FIELD SERVICE CAMPAIGN – 16129

HX™ Series Front Turn Signals

HX™ Series

Figure 1. Headlight and Turn Signal Main Harness Connector

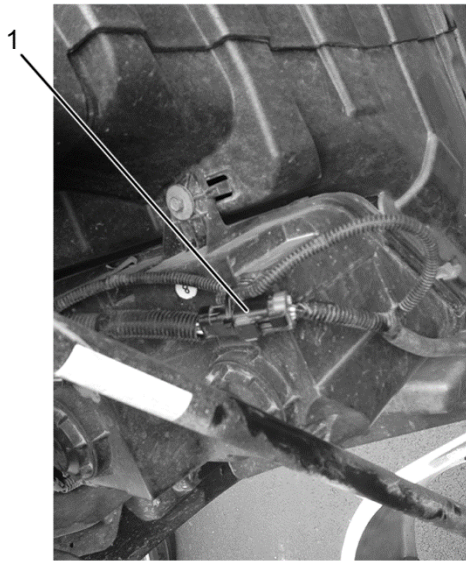
On certain HX™ Series vehicles, built between 08 December 2016 and 24 August 2016, when operating in extreme heat with the headlights on and when either turn signal is activated, the front turn signal may stop flashing and remain on steady.

1. Connector
5. Access operator-side headlight harness. Disconnect harness connector (Figure 1, Item 1).
6. Install jumper harness into both sides of connector. Ensure secondary locks are secure.
7. Using cable wire tie, secure jumper harness to main hood harness.
8. Repeat Steps 5 through 7 on passenger side of vehicle.
9. Close and latch hood.
10. Remove wheel chocks.
